RE: Submittal of Report for RCRA Facility  
Investigation  
TWC Permit for Industrial Solid Waste Management  
Site Number HW-50216  
EPA Hazardous Waste Permit Number TXD083570051

RE: RCRA Facility Investigation (RFI) Work Plan  
Review; Hazardous Waste Permit No. HW-50216;  
Industrial Solid Waste Registration No. 30614;  
EPA Registration No. TXD 083570051

**RESPONSES TO JULY 8, 1991 TWC COMMENTS  
RCRA FACILITY INVESTIGATION REPORT  
FMC CORPORATION  
PASADENA, TEXAS**

GROUNDWATER POTENTIOMETRIC  
SURFACE MAP OF POND AREA  
DATE MEASURE : 7-19-91  
EMC CORPORATION, BAYPORT PLANT  
PASADENA, TEXAS

INCINERATOR

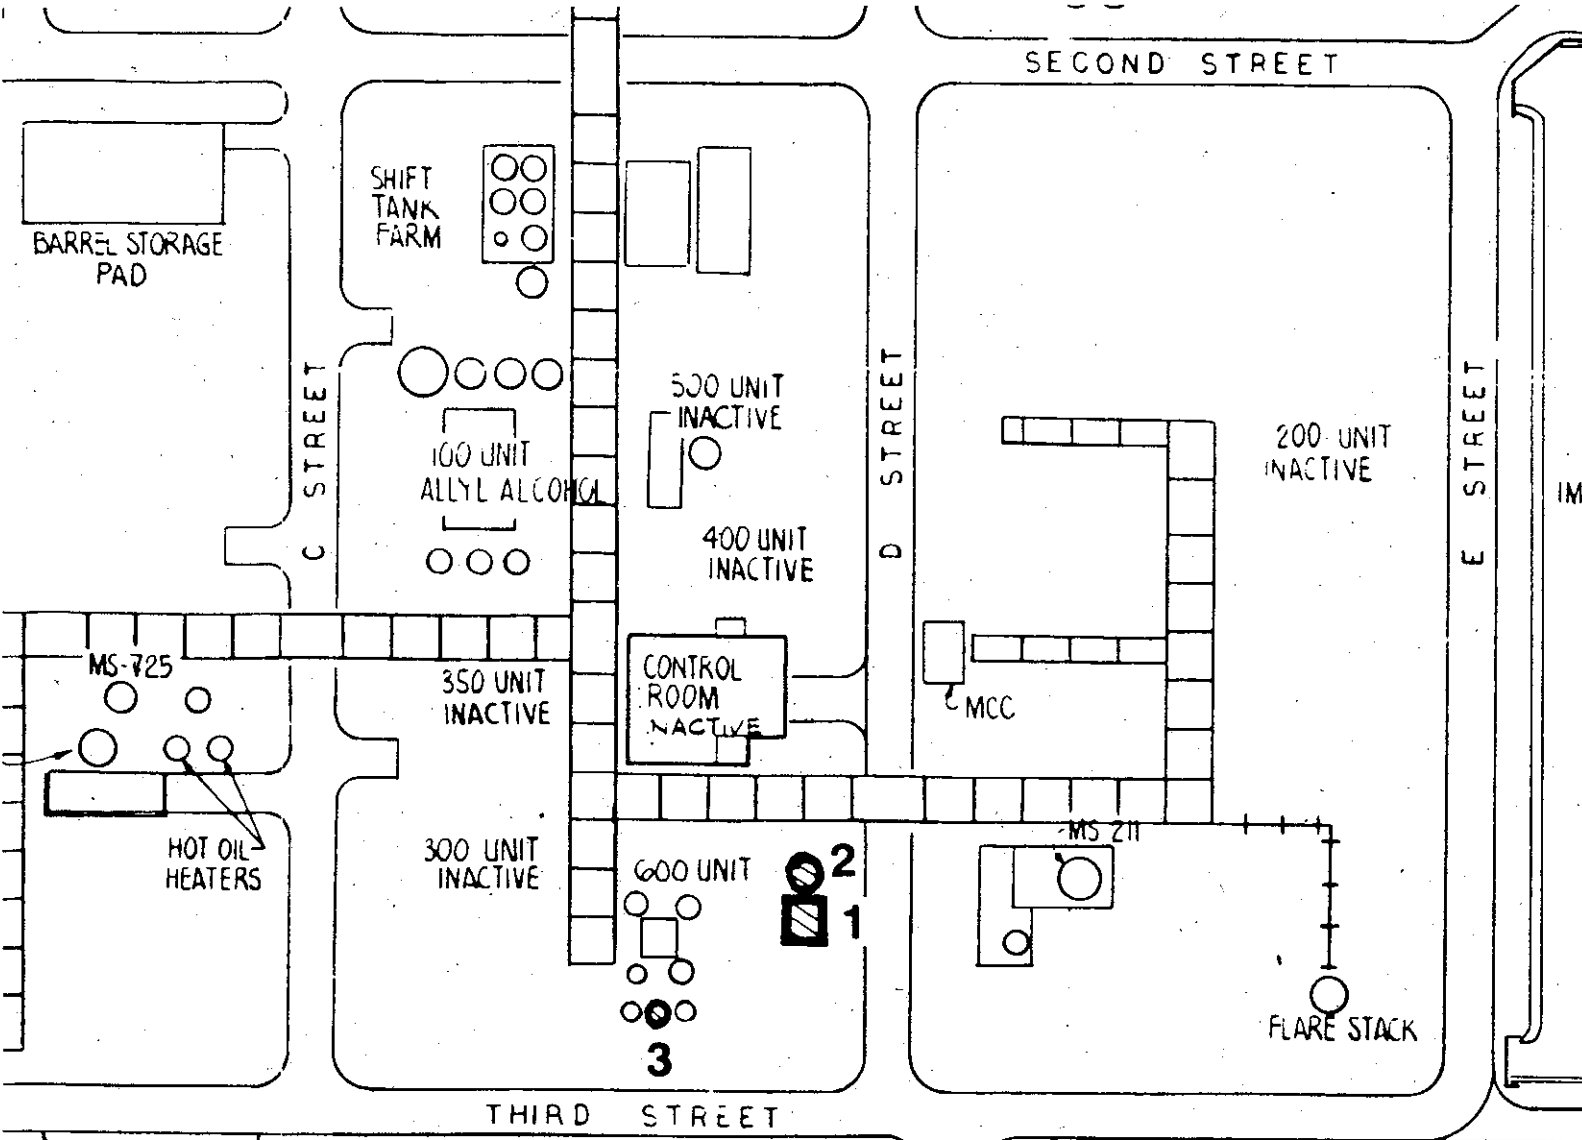
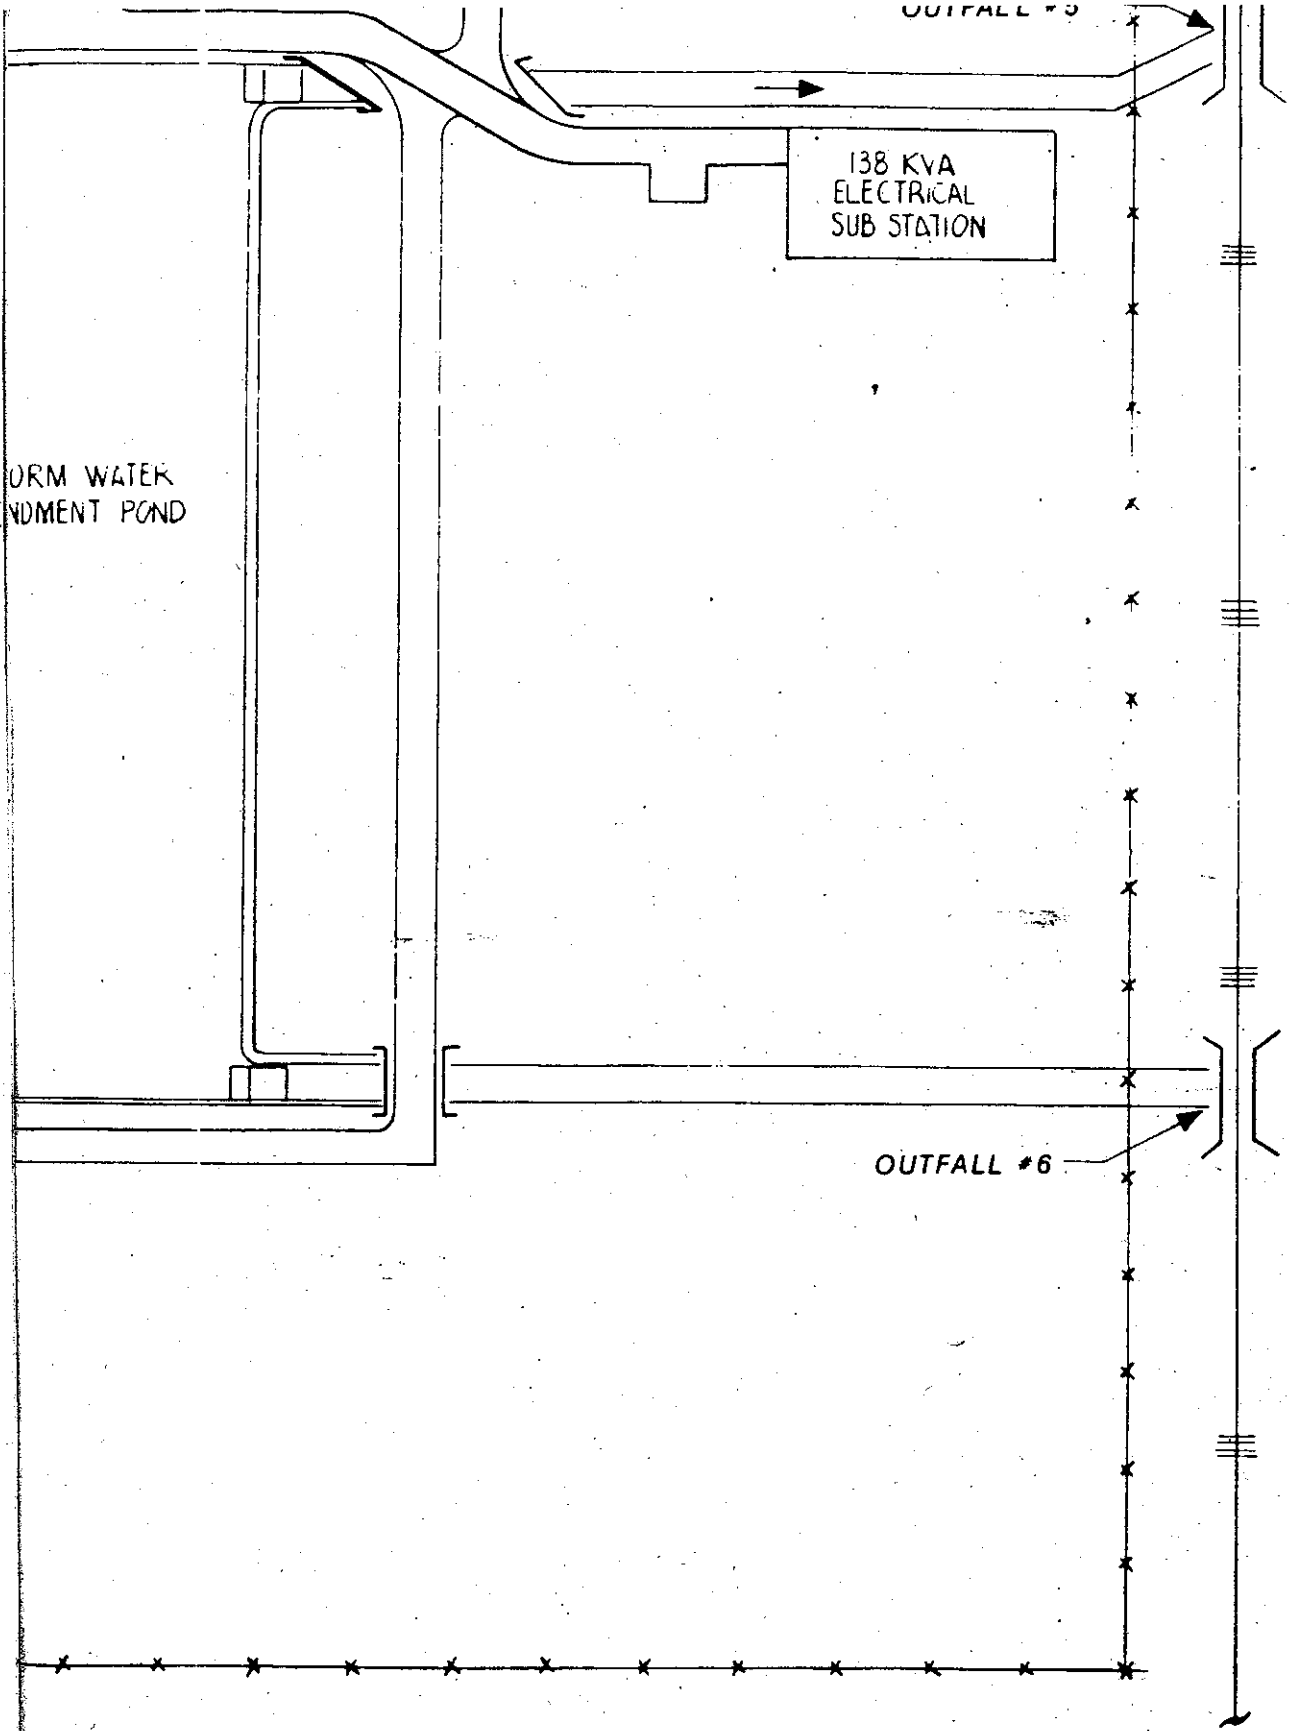
"Permit Provision VIII.A.2.b. is specific about characterizing encountered groundwater depth and movement. Your report suggests groundwater was encountered; however no specifics about inferred flow vector (i.e. velocity and direction) and encountered elevations were reported. Therefore, we require that you submit these data. Please be aware that the groundwater information for which we are asking is necessary for characterization purposes and should not be mistaken for the results of a groundwater study as specified in permit Provision VIII A.2.b.(2)."

The static water level measurements are presented below. Monitor well locations are shown on the attached map.

These water level measurements were used to calculate groundwater elevations and develop the attached potentiometric surface map. This map indicates that the direction of groundwater flow is northeast.
